ARCHITECT'S SUPPLEMENTAL INSTRUCTIONS

PROJECT:	The Reserves at Magnolia New Apartment Complex Denton, TX	Report No.	One (1)
OWNER:	Overland Property Group Dan Maximuk 234 N. Santa Fe Ave, Suite A Salina, KS 67401	Date	Oct. 22, 2024
CONTRACTOR:	Snyder Construction Group 4820 N. Town Centre Dr. Ozark, MO 65721	Architect's Proj No.	21-3205
		Contract For:	General Construction Mechanical, Electrical

Please Note: Drawings and Specification Edits associated with this ASI are dated as **7-17-2024**. This date above is the date this ASI was issued.

COPYRIGHTED ©

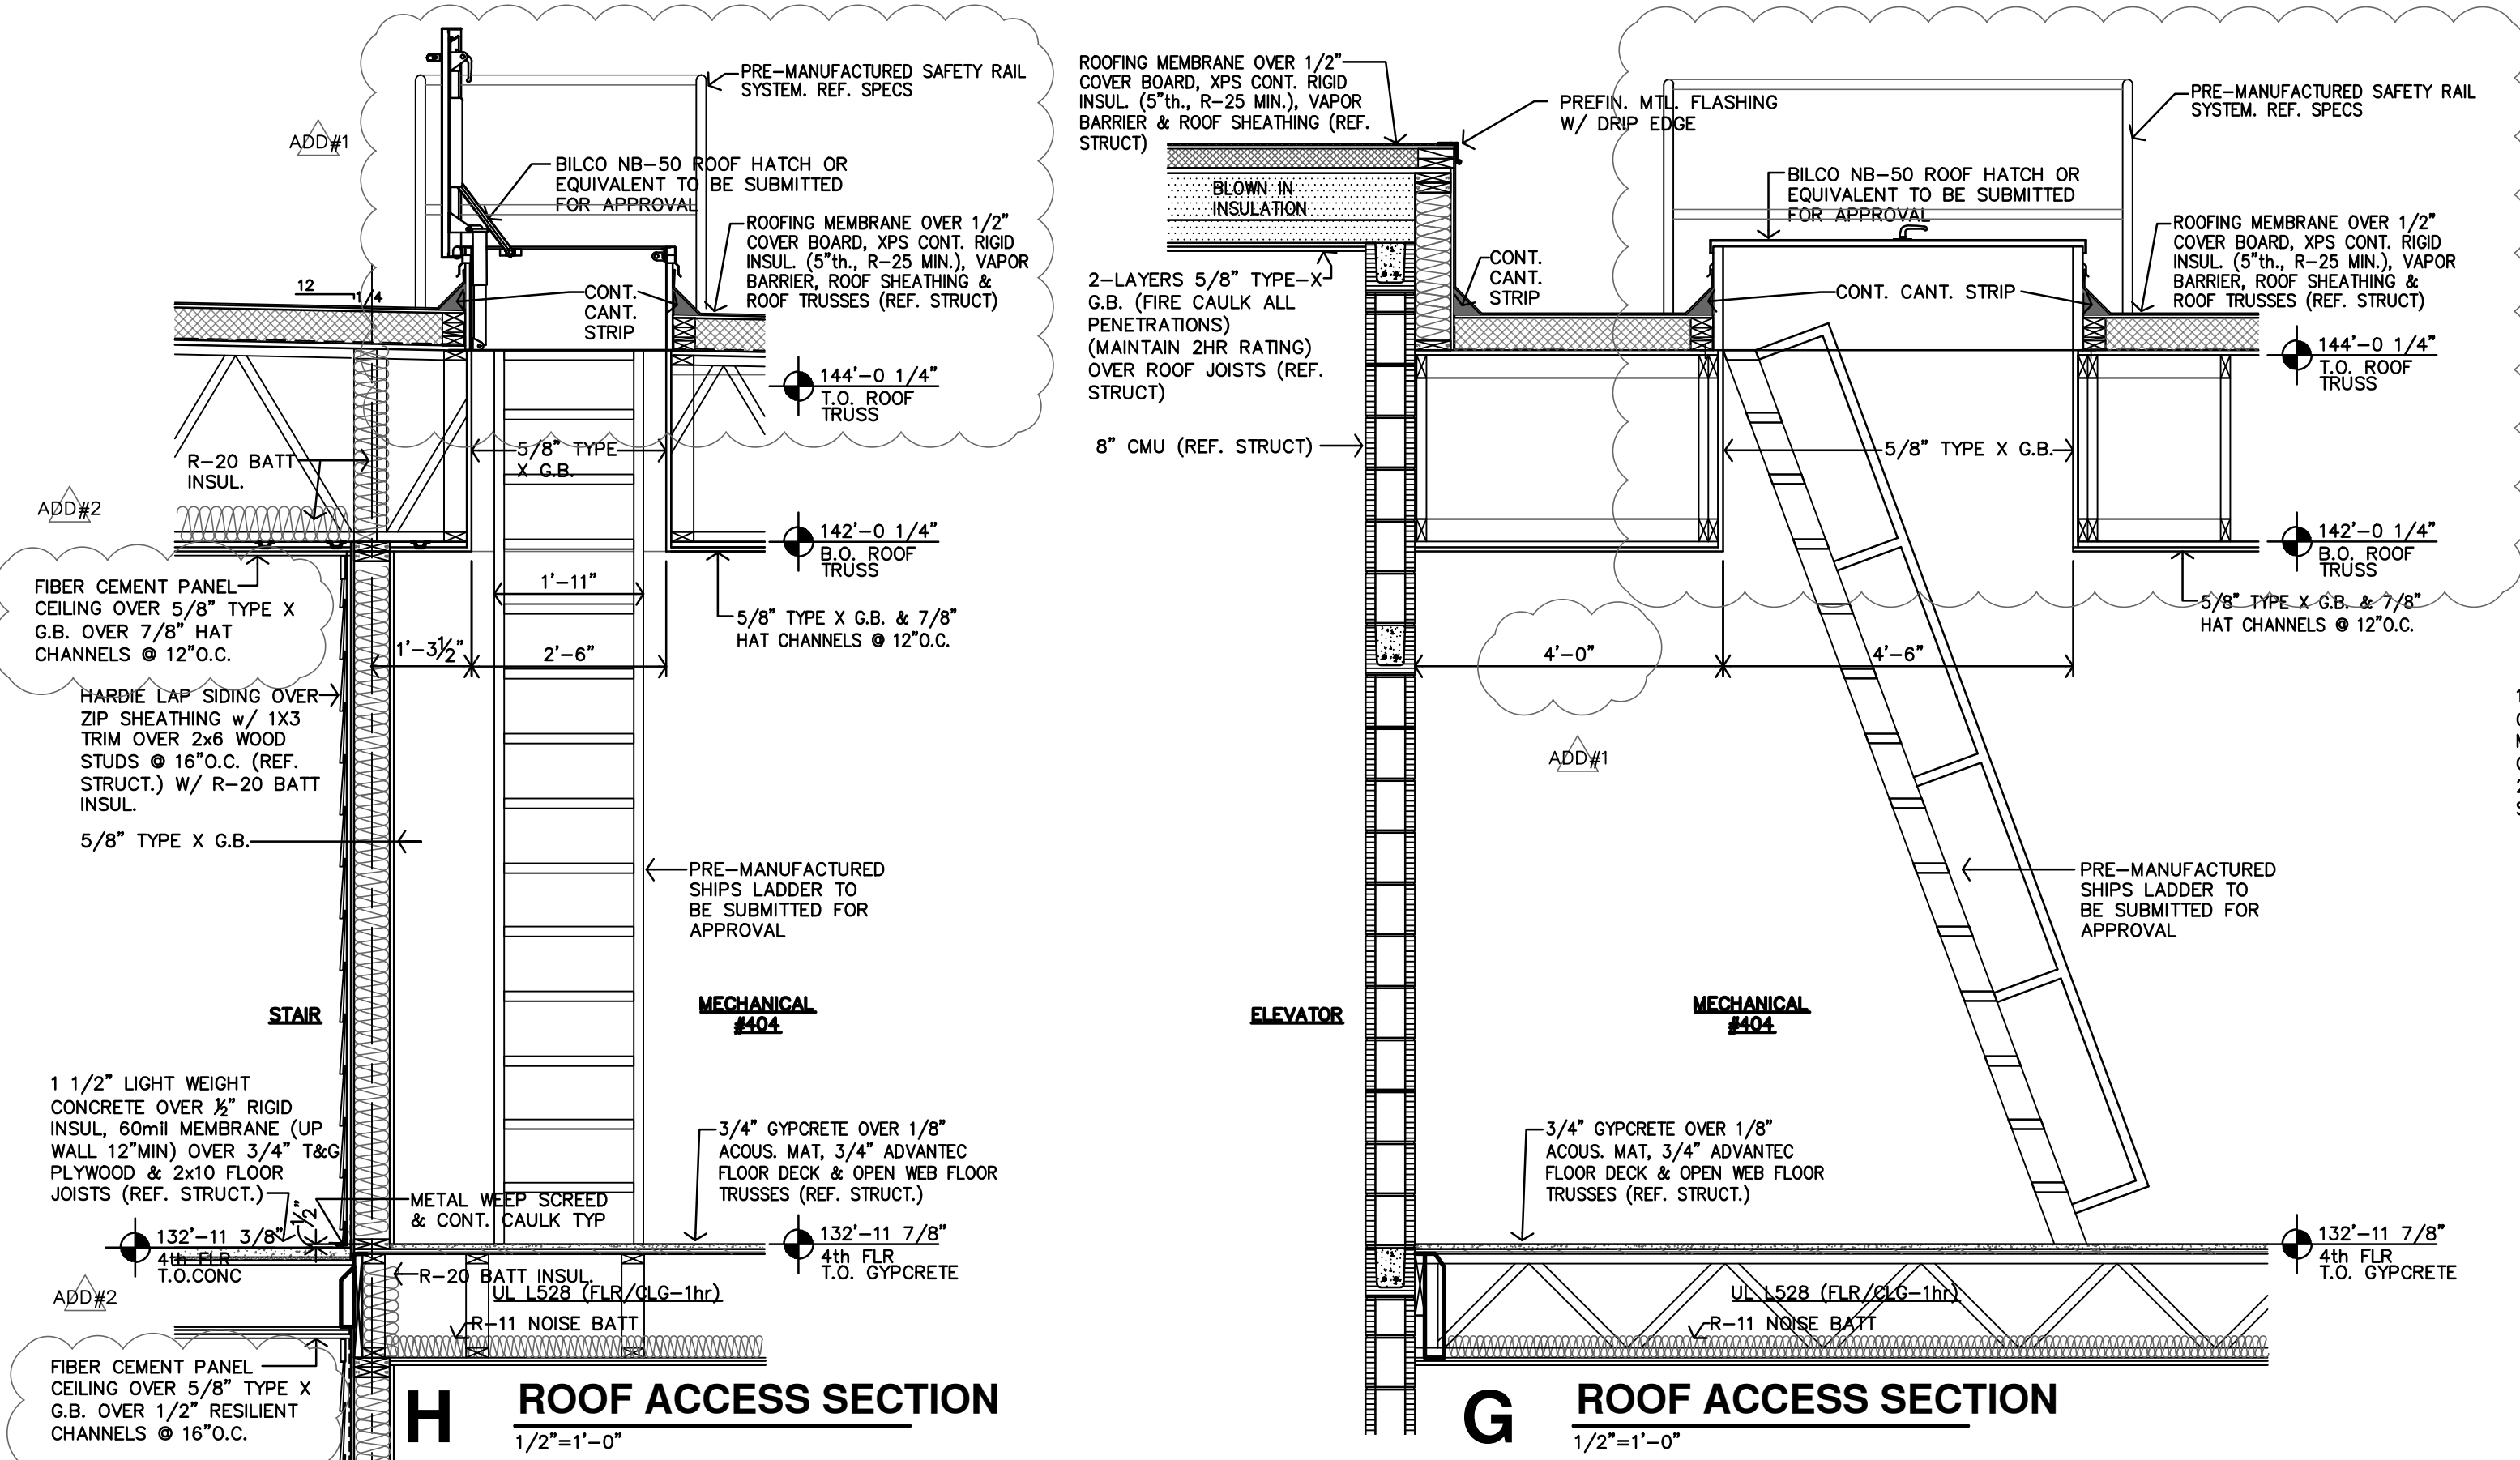
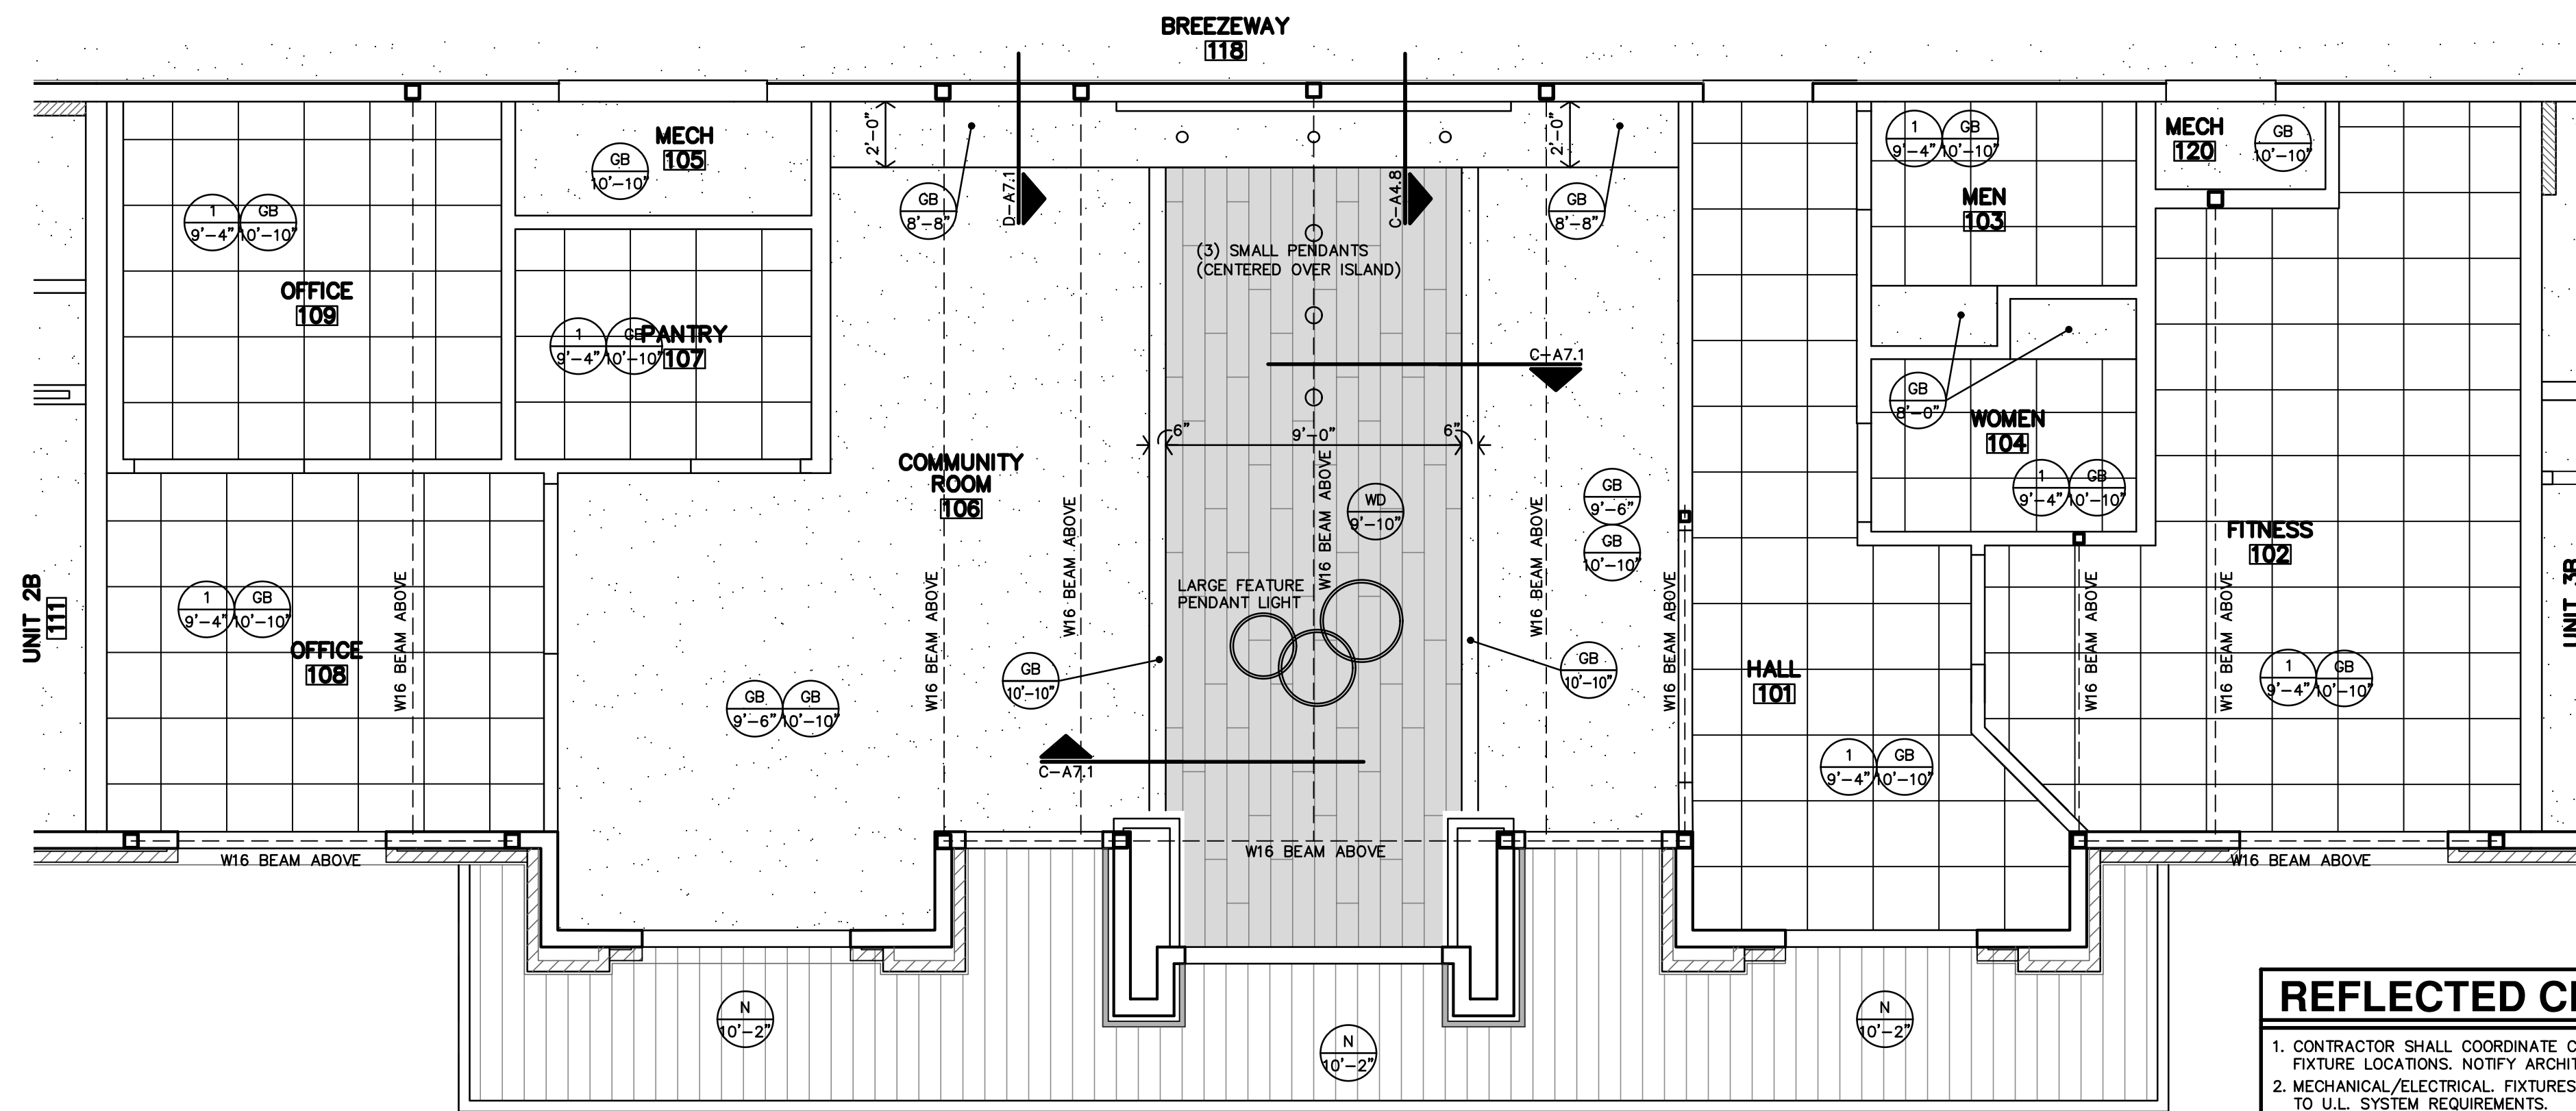
- 7) Utilize standard vertical pickets at the metal stair/landing handrails/guardrail systems in lieu of the custom metal panel railings. (VE Item #10). Reference revised details on Sheets A6.2 & A6.3.

- 17) Omit Security Gate and Doors #114, #116, #121 and #122. (VE item #22). Reference revised plans and details on Sheets A2.1, A3.1, A3.2, A6.1, A6.2 and A10.2.
